HUDSON RIVER EPS Peer Review Report

DRAFT

Figure 2: EPA Phase 1 Report March 2010, Figure I-3-18a

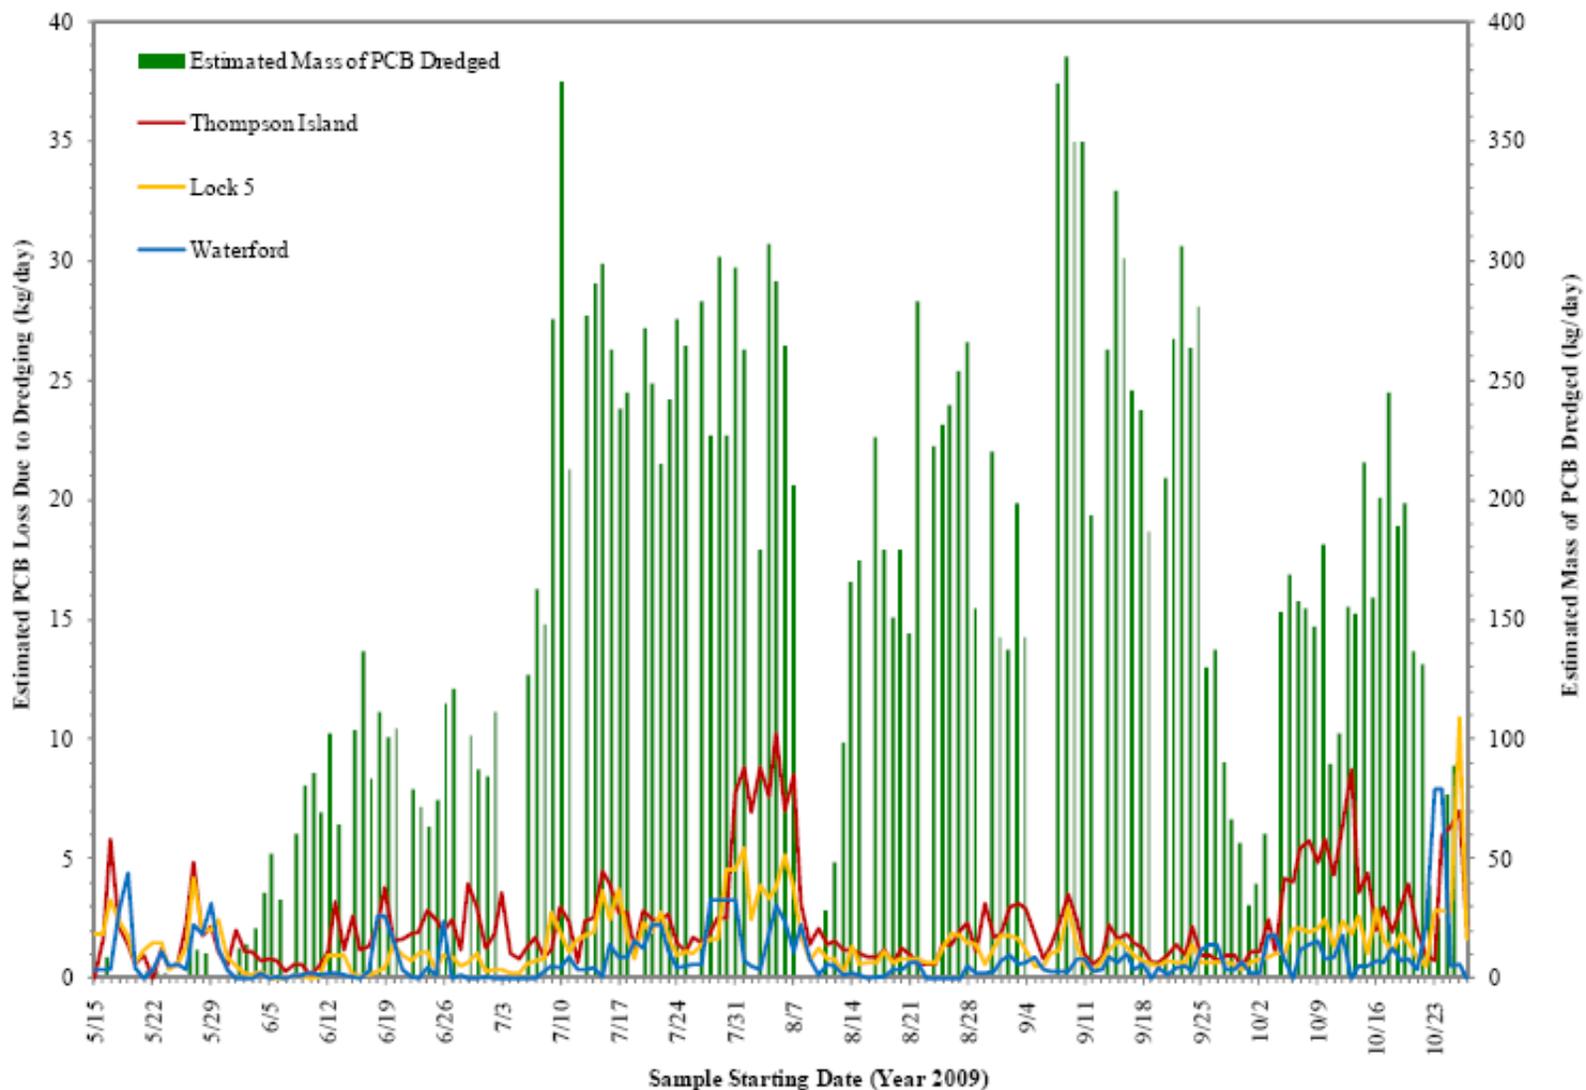
EPA’s Phase 1 Report Figure I-3-18a (Figure 2) presents a compelling representation of PCB mass removed against losses measured at TIP, Lock 5, and Waterford. The Panel confirmed EPA’s mass removal projection with the data in GE’s Appendix Table G-1c (Summary of Daily Bucket Analysis by CU), and the release rates at the TIP with GE’s Figure 5.3-8 (Net Total PCB concentrations at Thompson Island) (Figure 3). While dredge releases are a contributor, there does not appear to be a consistent relationship between mass removed and mass lost solely by the physical act of dredging. Based on EPA’s

analysis, PCB release is not solely controlled by dredging rates or mass removed. GE presented an empirical model that relies on rates of dredged PCB mass removed plus current velocities to predict water column PCB concentrations and resuspension release rates at Waterford. The model reasonably predicts Waterford PCB concentrations, suggesting a strong relationship between PCB mass removed and river flow velocities. This information, combined with EPA's analysis, suggests that river flow was a significant contributor to PCB resuspension and release. What is unclear is the extent to which the various aspects dredging operations contributed to resuspension and release (e.g., open CUs, scow operations, dredge rates, dredge depths, bucket size, bucket overflow, and other dredge-related unit processes, such as single lane advance of dredging downstream).
